ADDENDUM NO. 2
Ottawa County Jail
Roof/RTU Replacement
BKL, Inc. - Project #787
January 3, 2022

CHANGES/CLARIFICATIONS TO DRAWINGS

4 TYPICAL COPING DETAIL @ EXERCISE YARDS
3" = 1'-0"

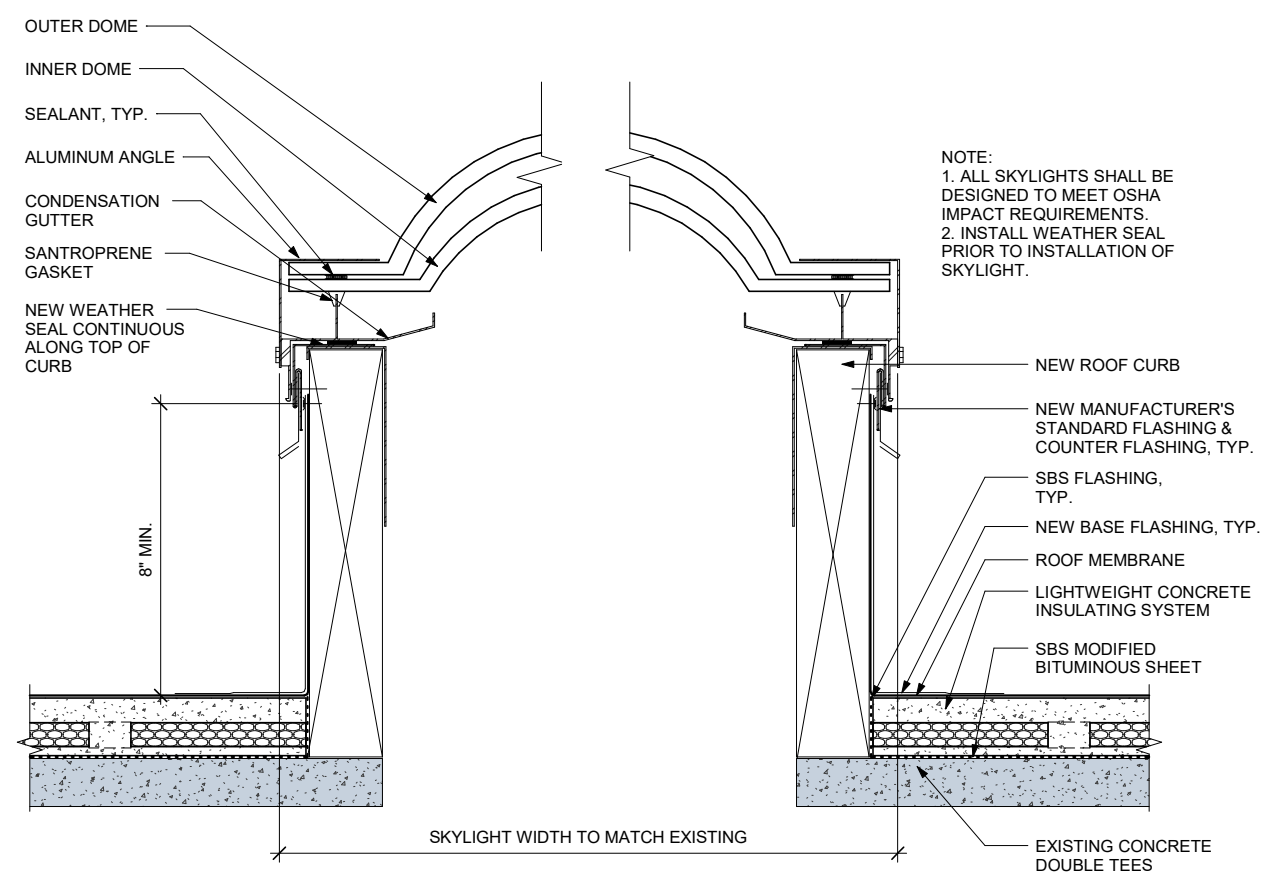
1. Sheet A2-01 – Revised detail 4 to include new flashing detail at steel angles and screens installed by owner.
2. Sheets M0-01, M1-01, M5-01, MD-01 – Revised to include replacement of ductwork at RTU1 and RTU 2 and replacement of EF-10 that is no longer functioning.

- NOTES:**
1. FABRIC MESH AT STONE CAP IS TO BE REMOVED AND REINSTALLED BY OWNER.
 2. STEEL MESH AND FRAMING IS TO REMAIN. COORDINATE ANY OBSTRUCTIONS WITH OWNER AND ROOFING MANUFACTURER.
 3. RAZOR WIRE, CAMERAS, AND OTHER SECURITY EQUIPMENT THAT INTERFERES WITH CONSTRUCTION IS TO BE REMOVED AND REINSTALLED BY CONTRACTOR.
